AGENDA  
Village of Chenequa  
Monday, May 13, 2024  
31275 W County Road K, Chenequa, WI 53029

## STAFF REVIEW

**Subject:** Site Plan Review

**Project Description:** Proposed Landscape Plan and Lighting Plan

**LANDSCAPE LIGHTING SCHEDULE**

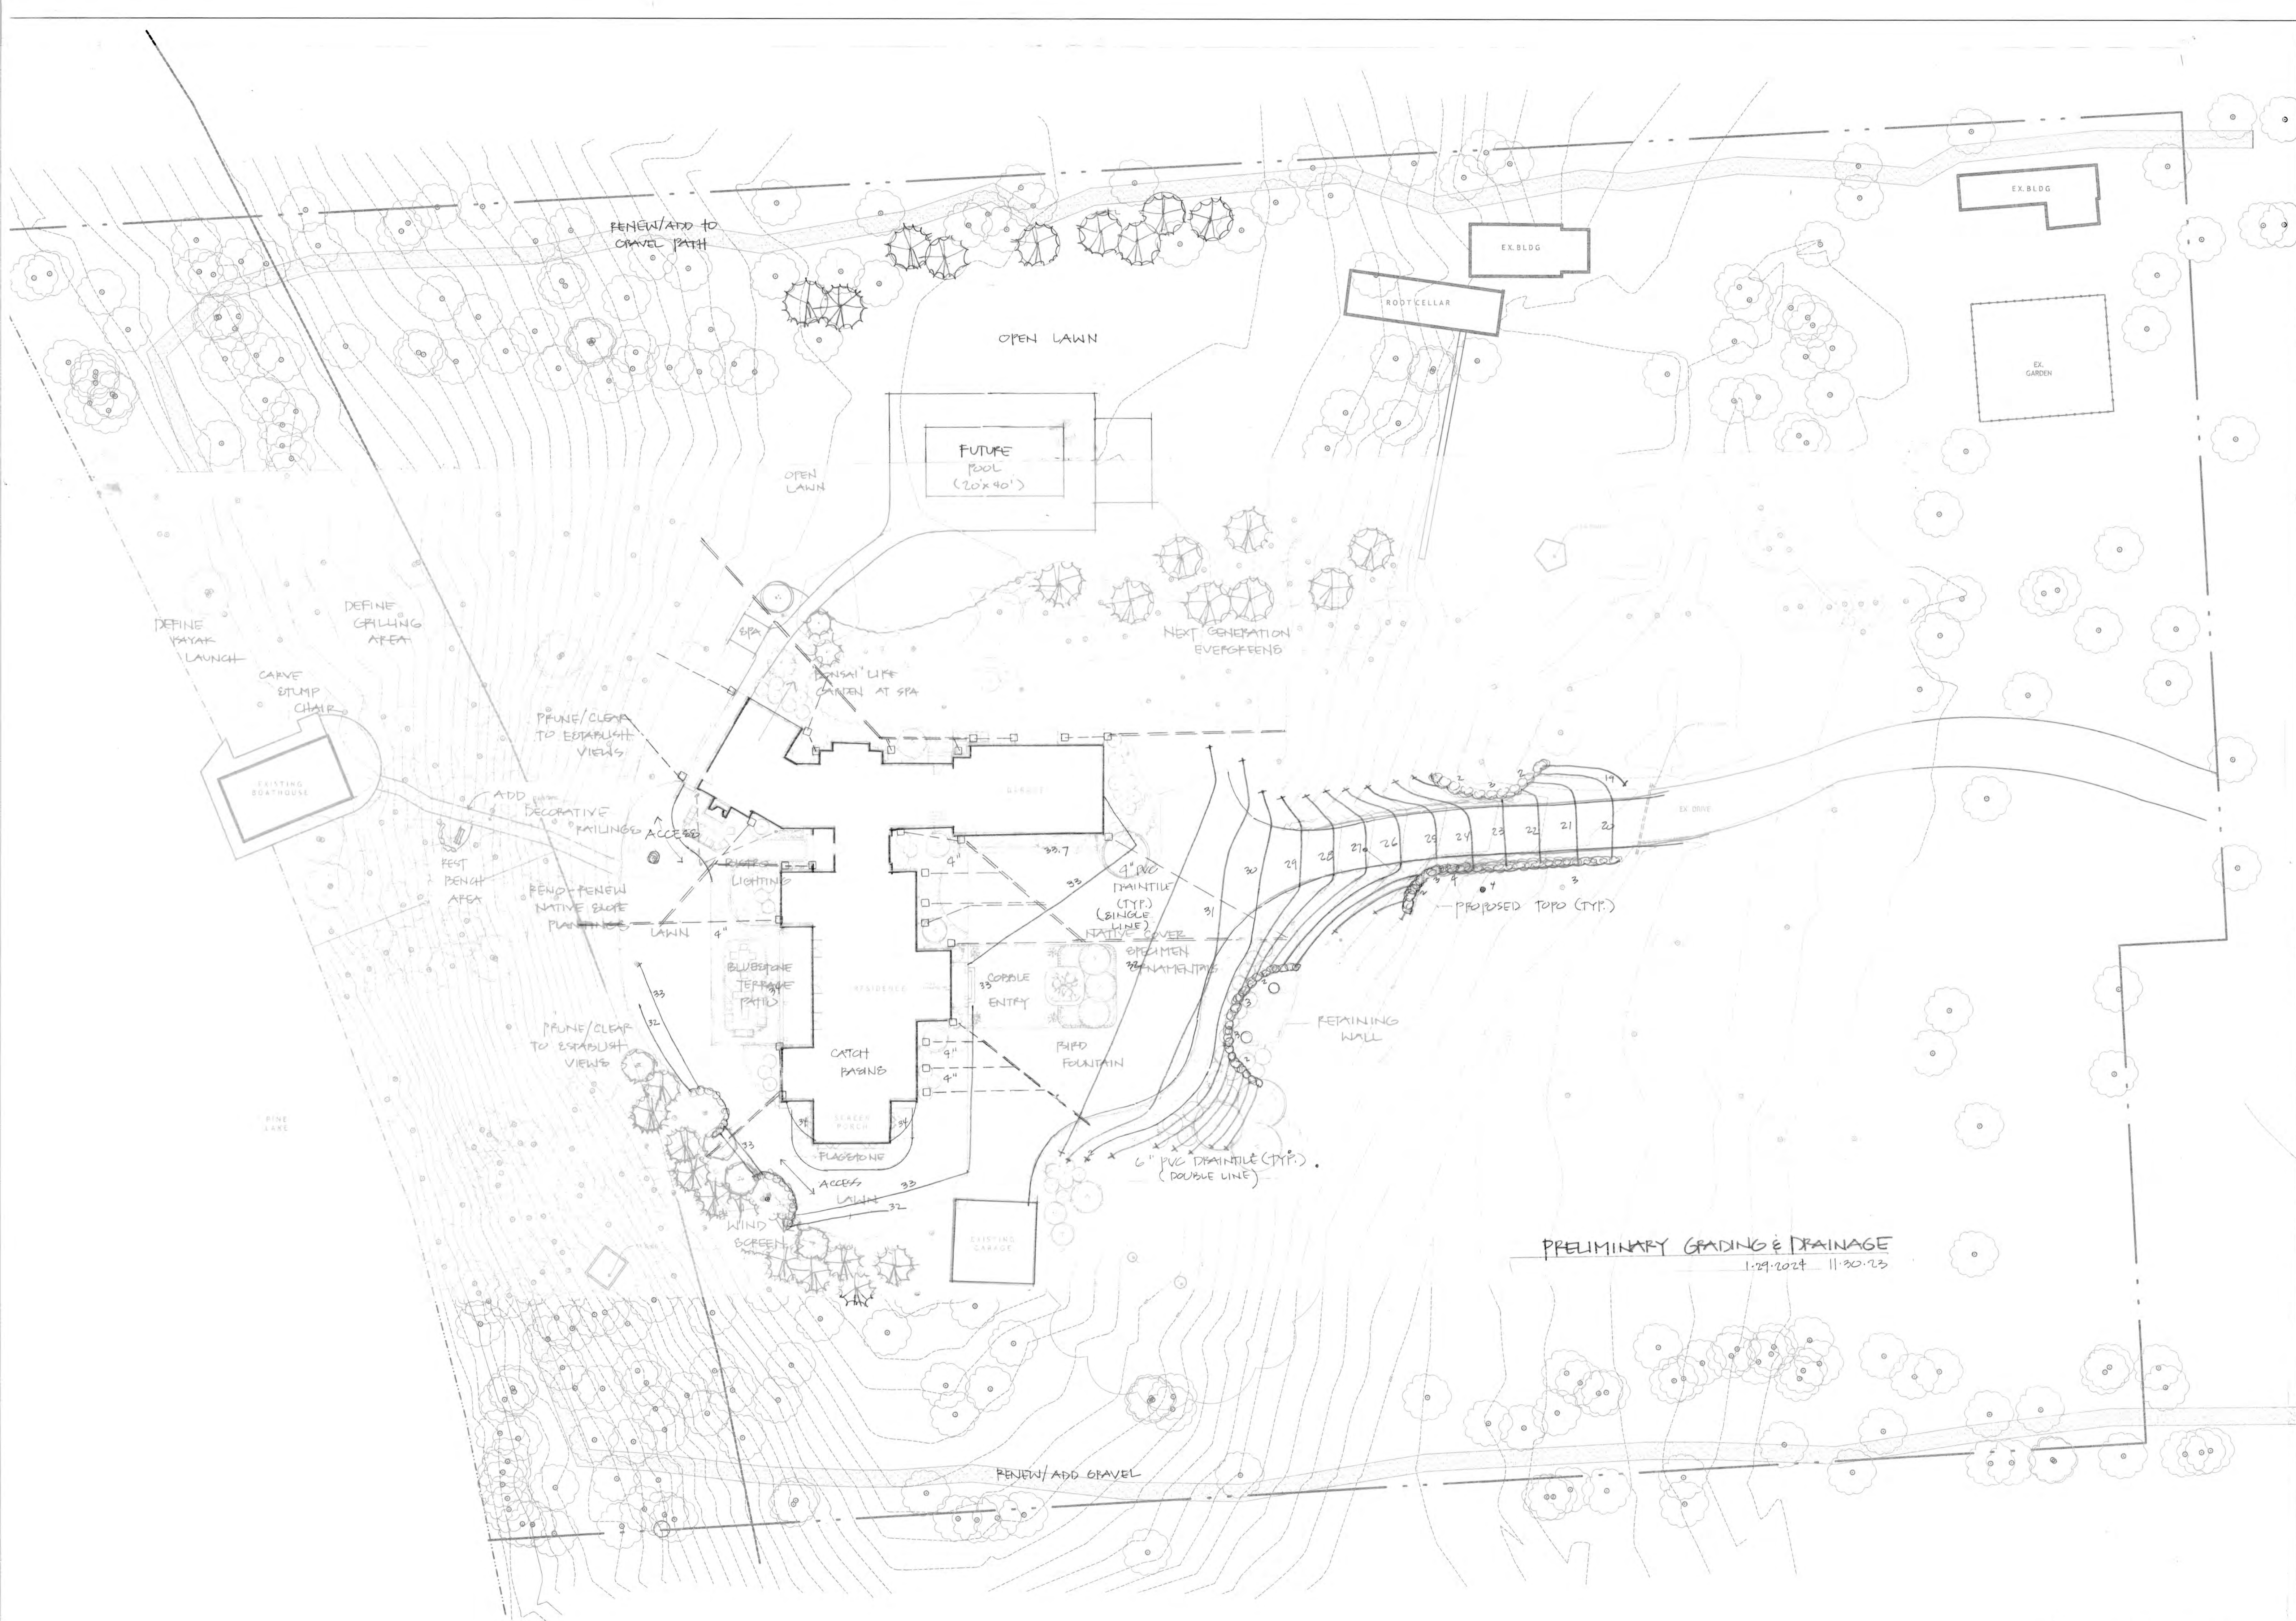
5. The landscape plan also proposes 17 fully shielded pathway lights around the property.
  - a. A spec sheet for the proposed landscape light is provided in the packet
  - b. The proposed lumen output per fixture is 35
  - c. The color temperature of these fixtures is 2,700K

SITE PLAN  
SCALE: 1/16" = 1'-0"

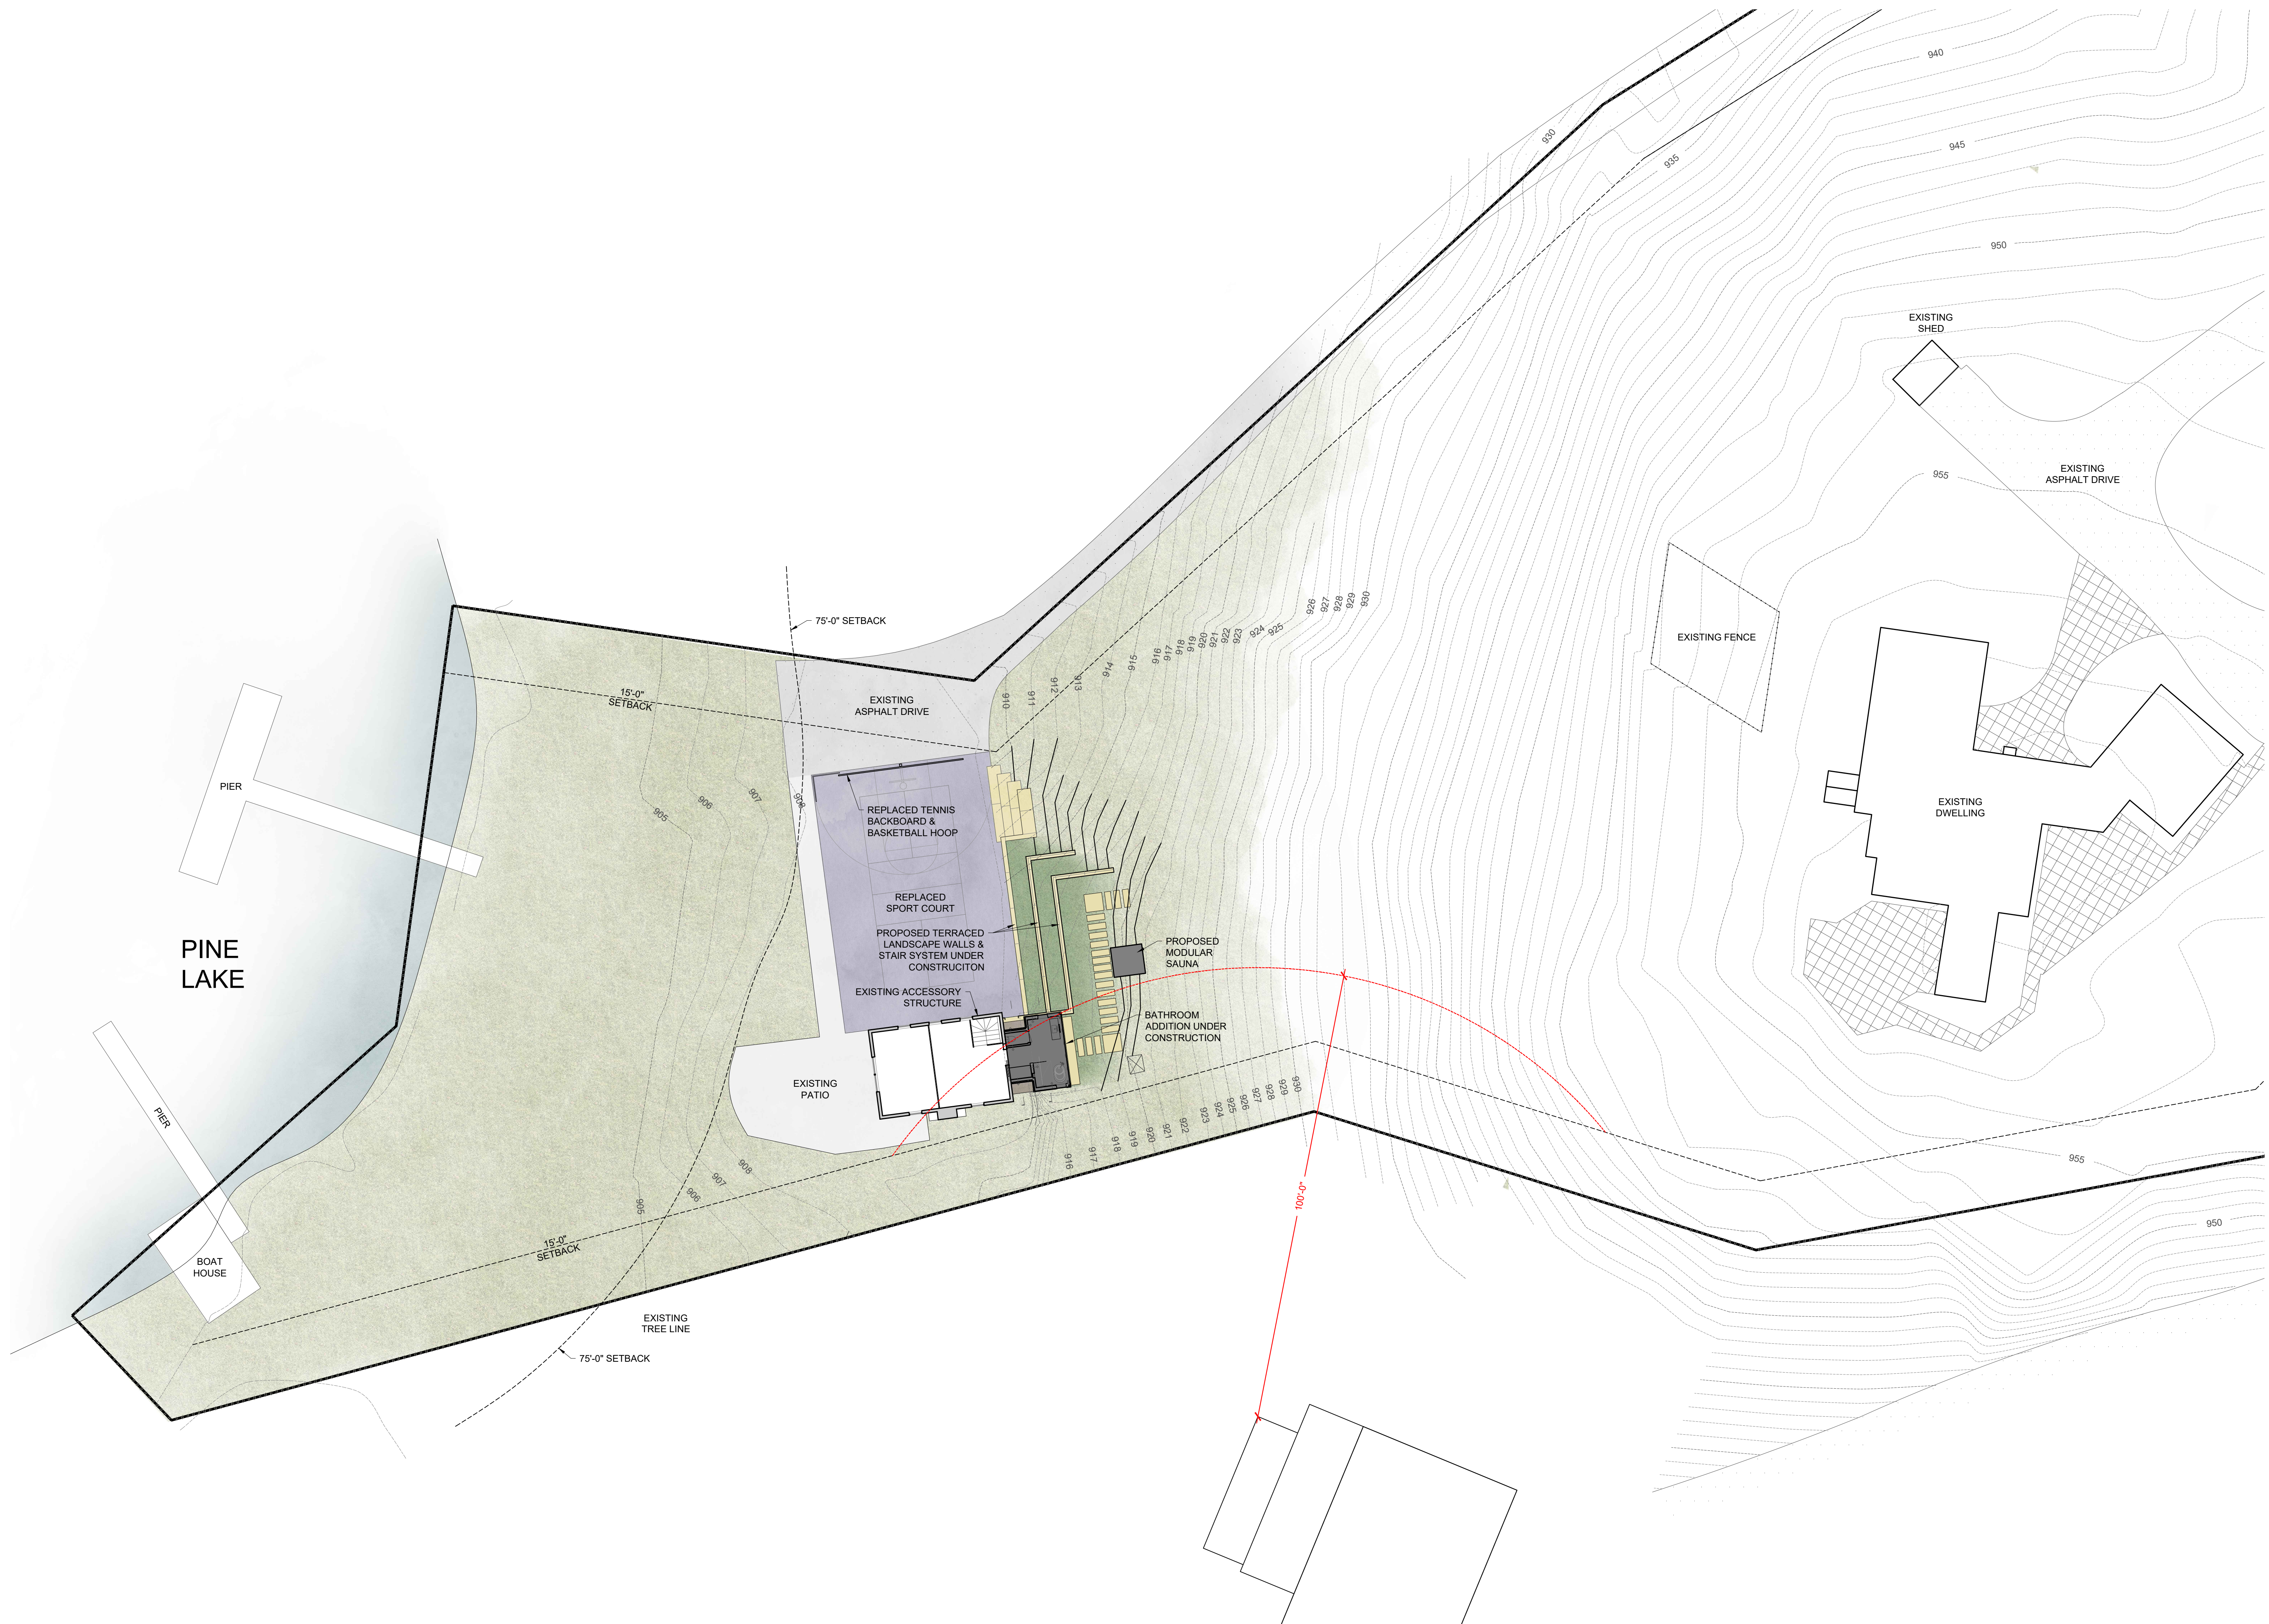
1. The applicant proposes to place a 6-person modular sauna structure on the lakeside of the primary dwelling.
2. The footprint of the sauna structure is approximately 45 square feet
3. The structure's exterior sheathing is constructed of wood-tone materials. The lakeside elevation is mostly glass.
4. "As seen from the lake" color renderings are provided in your packets
5. Proposed location has been shown on the site plan in the packets.
6. This structure meets the requirements of 6.5(4)(a)(i) because it is greater than 75' from the OHWM.
7. The proposed detached accessory structure is over one hundred (100) feet to any existing single-family structure on an adjoining lot which complies with section Sec. 6.5(c)(i).

SHEET  
PV-1

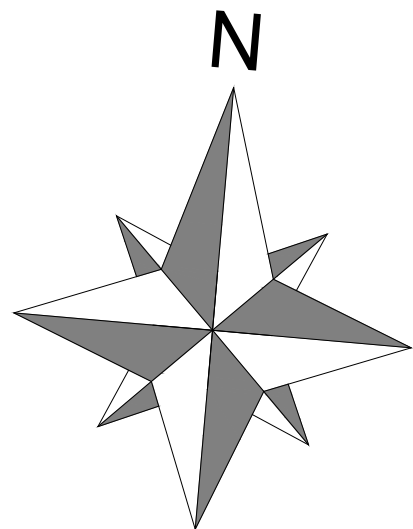
1. The applicant proposes to install two roof mounted solar arrays on the existing dwelling
    - a. Page three of the packet shows proposed panel locations
      - i. A 27-panel array is proposed to be mounted over the garage and facing southward
      - ii. A 17-panel array is proposed to be mounted on the house facing westward.
  2. The proposed panels will not result in an increase in structure height
  3. The proposed panels are pure black as shown on page 9 of the included packet.
  4. This is a legal conforming lot
- c: Dan Neumer, Administrator  
Deanna Braunschweig, Clerk  
Paul Launer, Lake Country Inspections  
Denise Spusta, Owner  
Cody Lincoln, Zoning Administrator
